10BT Amplitude Optimization

Mandeep Chadha
Dan Sturca

Figure 14-7—Twisted-pair model

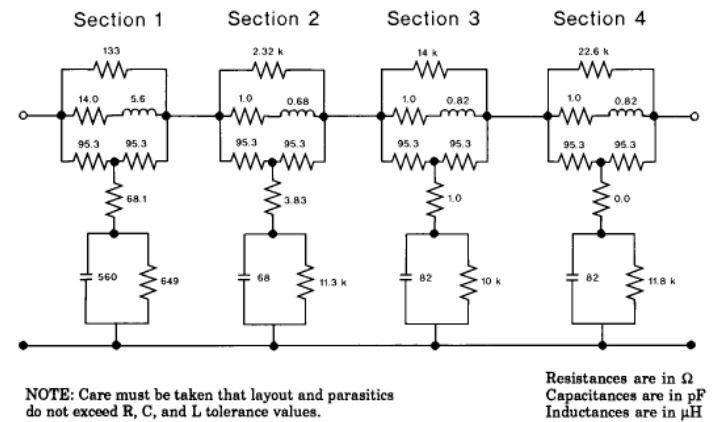
- ▶ TPM (Fig 14-7) sims
 - ▶ Insertion Loss @ 5MHz: 6.69dB
 - ▶ Insertion Loss @ 10MHz: 9.88dB

- ▶ Delta Cat-5/5e vs. TPM

- ▶ 2.16dB @ 5MHz
- ▶ 3.38dB @ 10MHz

Figure 14-9—Voltage template

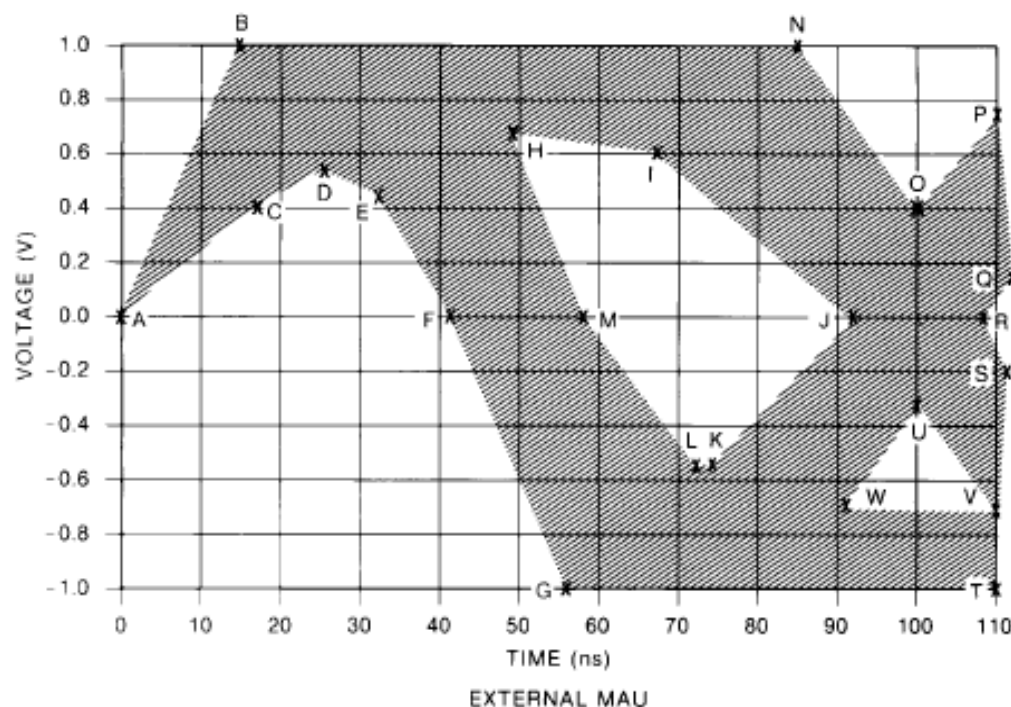
- ▶ An amplitude reduction of 3dB is safe to maintain full compatibility with Cat-5/5e or better cabling and legacy PHYs
- ▶ The 5MHz content can be managed by proper pre-emphasis or by slightly reworking points H, I, L, and K of the template

- ▶ Minimal work on Fig 14-9:
 - ▶ Redefine the values for points H, I, L, K

- ▶ Remark: A typical 10BT signal after 100m Cat-5e cable DOES NOT fit Fig 14-9 template ($2.5V * 0.473 = 1.18V$)
